PILATUS AIRCRAFT LTD, STANS, SWITZERLAND

SERVICE BULLETIN

Service Bulletin No: 27-021 Ref No: 331

FLIGHT CONTROLS - AILERON CONTROL SYSTEM AILERON TAB COUNTER BALANCE WEIGHT INCREASE

Aileron Trim Tab - Removal/Installation Figure 1

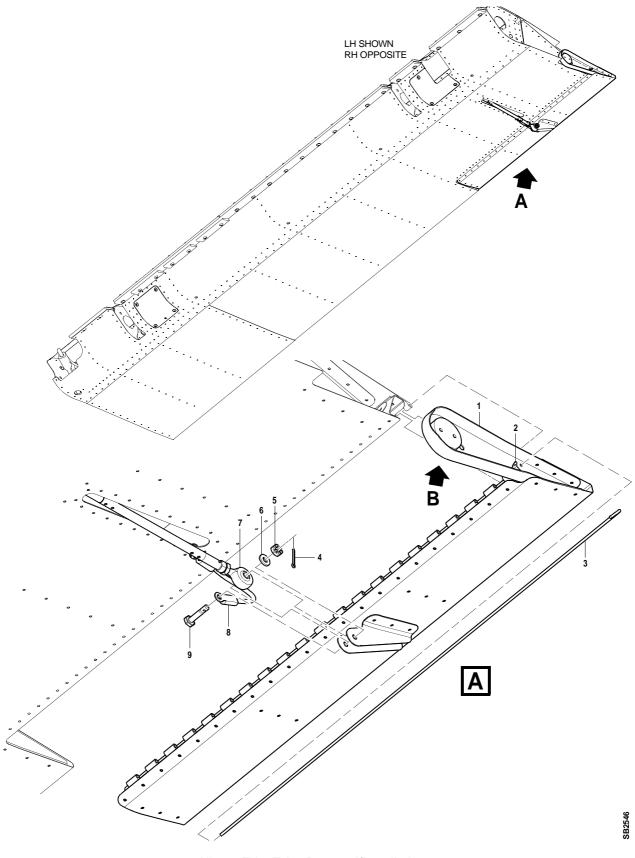
- (1) If installed, remove the trim tab from the aileron, refer to Figure 1:
 - (a) Remove and discard the cotter pin (4).
 - (b) Remove the nut (5) and washer (6) from the control rod bolt (9).
 - (c) Remove the control rod bolt (9) from the trim tab brackets.
 - (d) Disconnect the bonding lead (8) from the bolt (9).
 - (e) Disconnect the control rod eye end (7) from the trim tab (1).
 - (f) Remove and discard the lockwire from the trim tab hinge pin (3) and the lockwire tab (2) on the trim tab.
 - (g) Hold the trim tab (1) then remove and keep the hinge pin (3).
 - (h) Remove the trim tab from the aileron.

- (1) Install the aileron trim tab on the aileron:
 - (a) Align the trim tab hinge with the hinge half on the aileron.
 - (b) Install the trim tab hinge pin (3).
 - (c) Safety the trim tab hinge pin (3) with lockwire (Mat. No. P02-008) to the lockwire tab (2) on the trim tab.
 - (d) Put the control rod eye end (7) in the trim tab brackets.
 - (e) Install the bonding lead (8) on the control rod bolt (9).
 - (f) Install the control rod bolt (9) through the trim tab brackets and the control rod eye end (7).
 - (g) Install the washer (6) and the nut (5) on the bolt (9).
 - (h) Safety the nut (5) with a new cotter pin (P/N 940.17.02.502) (4).

Aileron Trim Tab Mass Balance Weight - Removal/Installation Figure 2

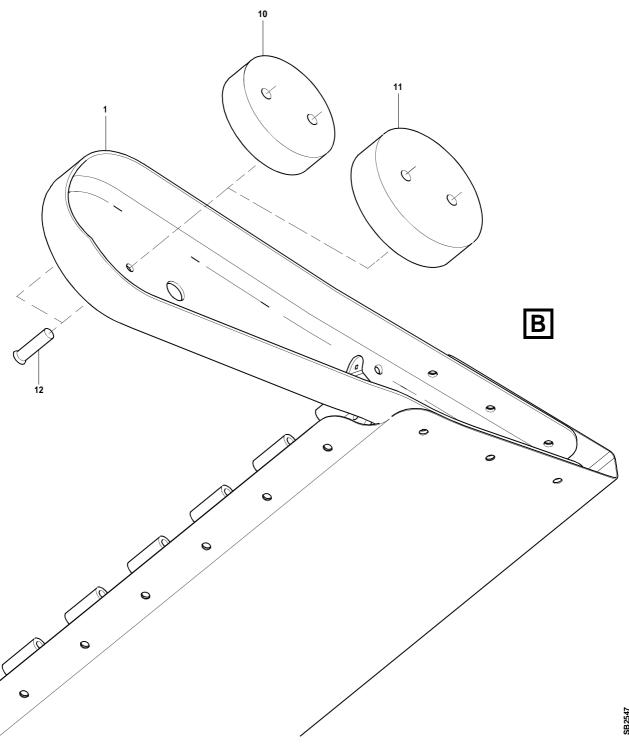
This Service Bulletin gives the data and instructions necessary to replace the aileron tab counter balance weight. The old counter balance weight has a diameter of 1.25 in. (31,75 mm) and a thickness of 0.34 in. (8,70 mm). The new counter balance weight has a diameter of 1.46 in. (37,20 mm) and a thickness of 0.39 in. (10,00 mm).

- (2) Carefully remove the two rivets (12) that hold the counter balance weight (10) to the aileron trim tab rib (1).
- (3) Remove the existing counter balance weight (10) from the trim tab.

- (4) Make sure that the surface finish on the trim tab rib (1) is clean and undamaged. Reprotect the rib as necessary.
- (5) Use sealant (Mat. No. P08-073) to wet assemble. Put the new counter balance weight (11) (P/N 527.15.12.105) in position on the trim tab rib (1).
- (6) Use sealant (Mat. No. P08-073) to wet assemble. Install two new rivets (12) (P/N 939.27.81.018) to hold the counter balance weight (11). Make sure that the countersunk rivet heads are in the trim tab rib.
